Subject: UniStar Nuclear Energy, NRC Docket No. 52-016
Submittal of Supplemental Information for the
Calvert Cliffs Nuclear Power Plant, Unit 3
Combined License Application
Schedule Issue 4 – Design Parameters for Category I Structure
Foundation Dimensions

Proposed changes to FSAR Section 2.5.4.10 (Enclosure) are provided to resolve the identified inconsistencies involving the Category I foundation dimensions described in the U.S. EPR FSAR and CCNPP Unit 3 FSAR.

COLA Markup Pages

Figure 2.5-103—(REVISED) (Subsurface Investigation Location Plan)

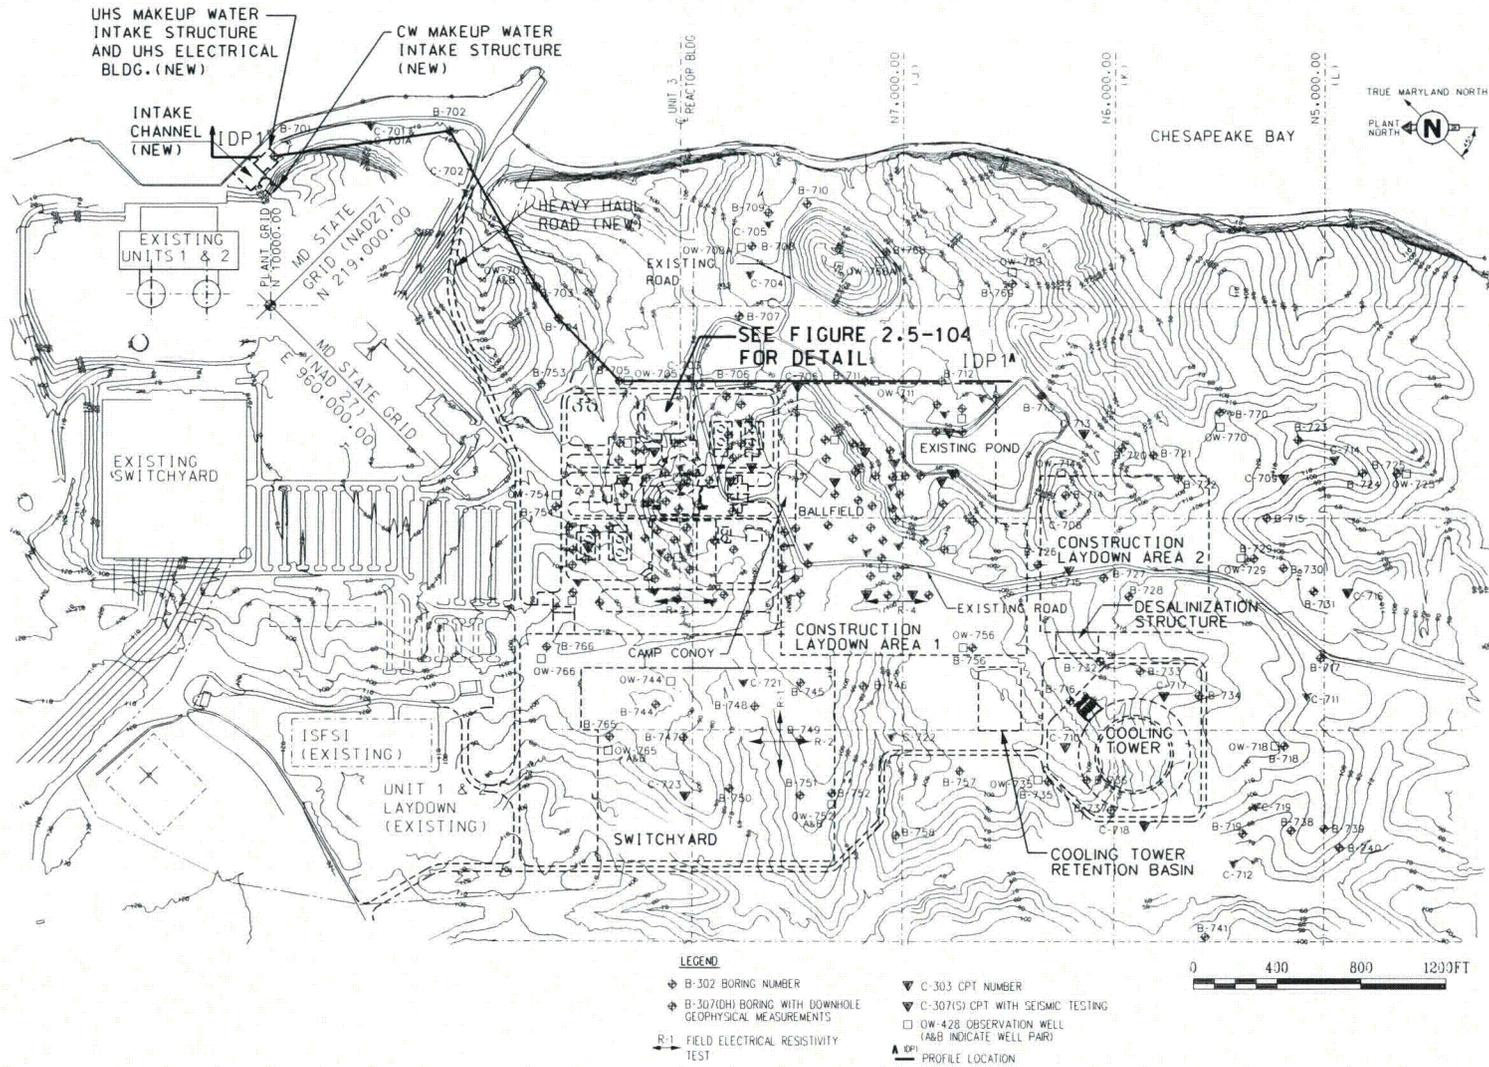
Foundation excavations result in removing about 2 million cyd of materials. The extent of all excavations, backfilling, and slopes for Category I structures are shown in Figure 2.5-130 through Figure 2.5-134. These sections are taken at locations identified in Figure 2.5-103 and Figure 2.5-104. These figures illustrate that excavations for foundations of Category I structures will result in removing Stratum I Terrace Sand and Stratum IIa Chesapeake Clay/Silt in their entirety, and will extend to the top of Stratum IIb Chesapeake Cemented Sand, except in the Ultimate Heat Sink Makeup Water Intake Structure area. In the Ultimate Heat Sink Makeup Water Intake Structure area, the foundations are supported on Stratum IIc soils, given the interface proximity of Strata IIb and IIc.

Structures locations and designations are shown in Figures 2.5-103 and 2.5-104. Other major structures in the power block area include the Nuclear Auxiliary Building, Access Building, RadWaste Building, and the Turbine Building, which are not Category I structures.
